Procedure No. W-SP-16

ADDENDUM 1, REVISION 2

REPAIR, INSPECTION, DOCUMENTATION, AND VERIFICATION

WATERFORD SES UNIT NO. 3

CORE GRID ON BLOCK 19

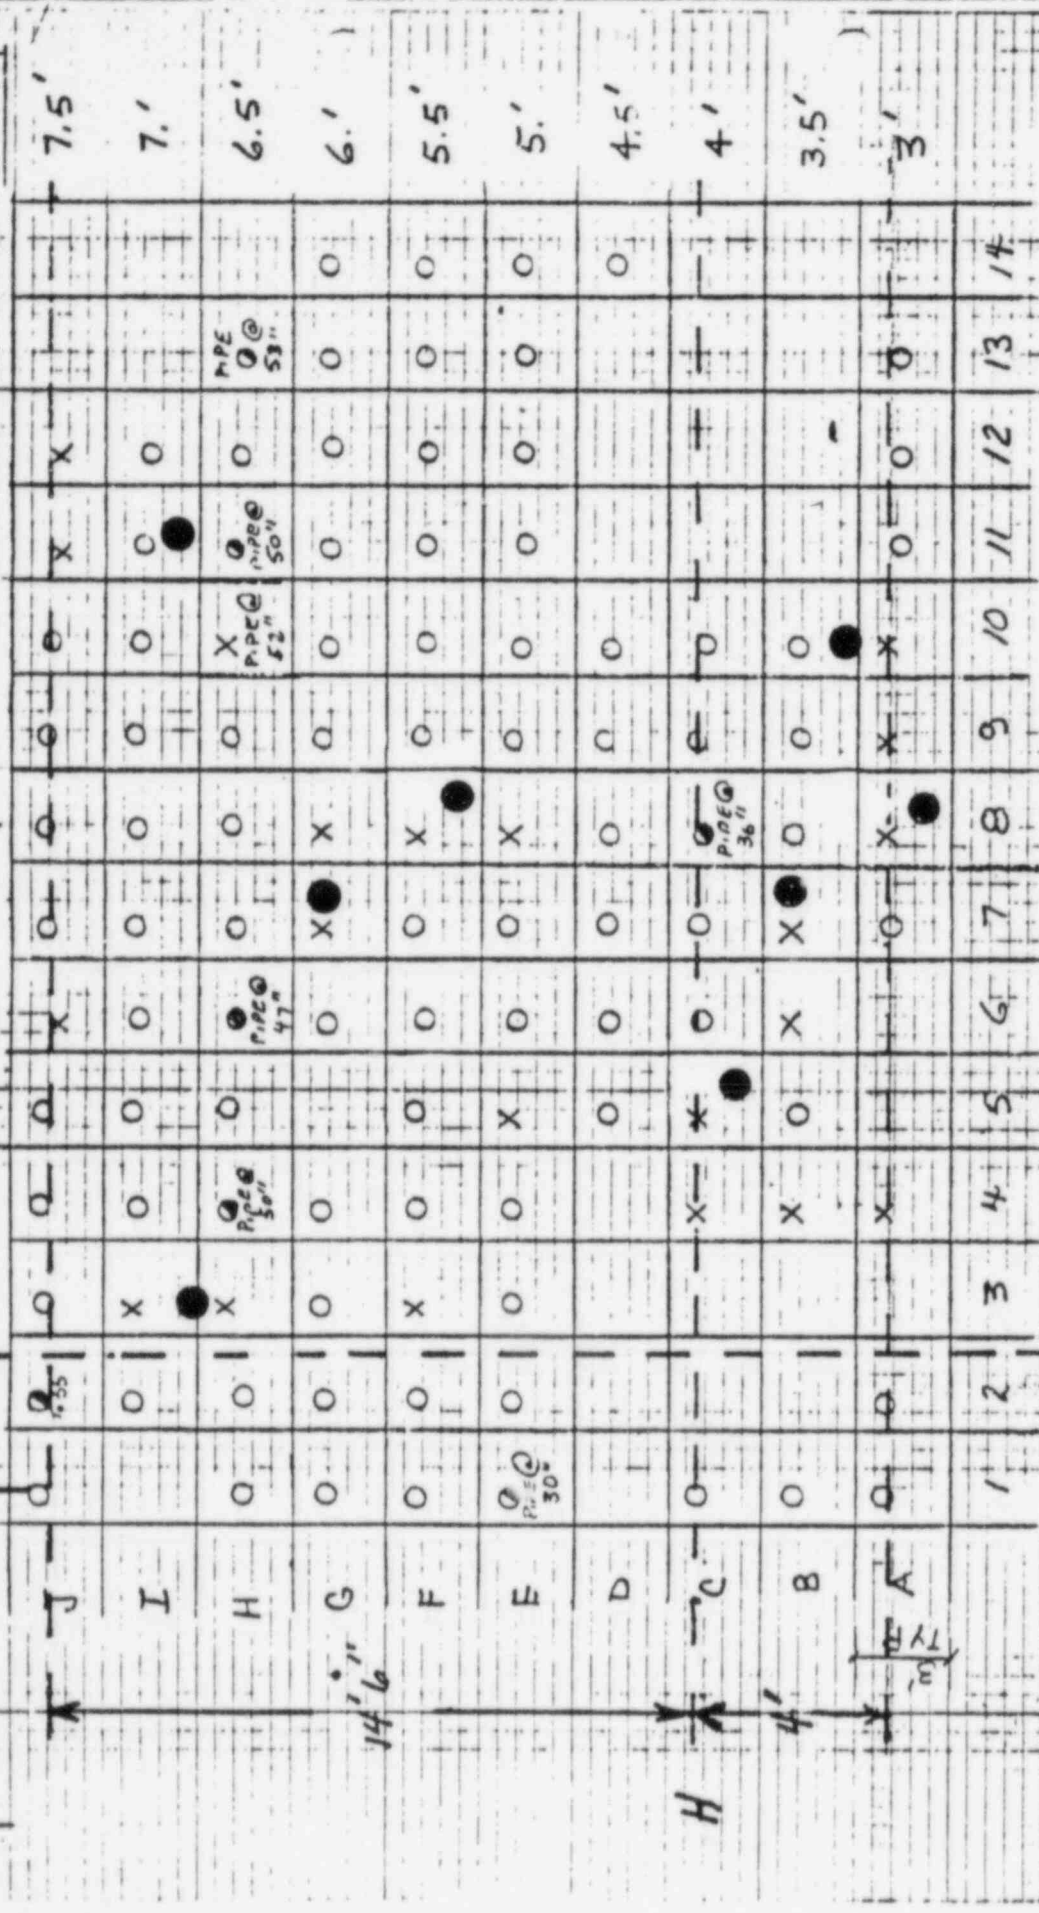
4.1 Eight (8) four (4) inch diameter cores shall be drilled in the vicinities listed below and to the depths listed below.

<u>SAMPLE</u>	<u>LOCATION*</u>	<u>DEPTH</u>
1	A8	4 FT.
2	B7 to B6	4 FT.
3	B10 to A10	4 FT.
4	C5 to C6	4.5 FT.
5	G7	6 FT.
6	F8 to F9	6 FT.
7	I11	7 FT.
8	I3 to H3	7 FT.

\* Locations are specified by grout hole numbers. See Attachment A.

4.7 The nine (9) additional two (2) inch diameter verification cores drilled to extend the northern limits of the core grid shall be grouted in accordance with W-SP-16, Revision 2.

4.8 The verification cores drilled in accordance with Paragraph 4.1 shall be grouted after the nine (9) two (2) inch diameter cores.
